IMSAI ECO 76-0061

Affected products: CP-A Rev-4

Modification to prevent memory writes during OUT instructions. For use with non-IMSAI memory boards.

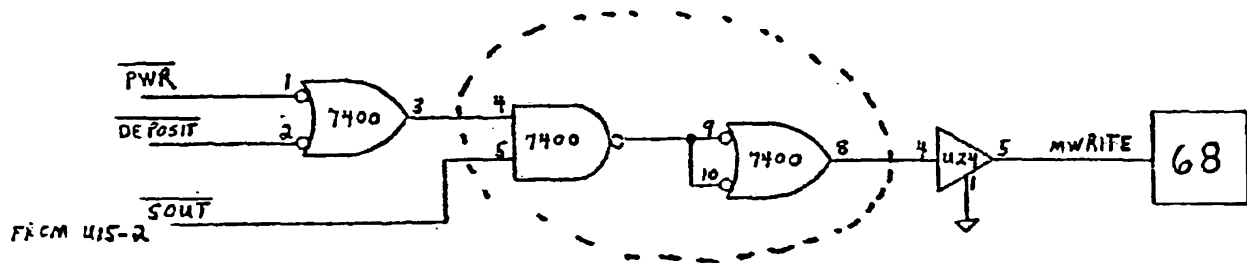
This modification should be made to your front panel board using two additional sections of the 7400 that in located directly above S2 and S3. This will keep your unit from writing into memory during an output.

1. On the component side, cut the trace between U24 pin 4 and U25 pin 3.
2. On the solder side, connect a jumper between U25 pin 3 and U25 pin 4.
3. On the solder side, connect a jumper between U25 pin 6 and U25 pins 9 and 10.
4. On the solder side, connect a jumper between U15 pin 2 and U25 pin 5.
5. On the solder side, connect a jumper between U25 pin 8 and U24 pin 4.
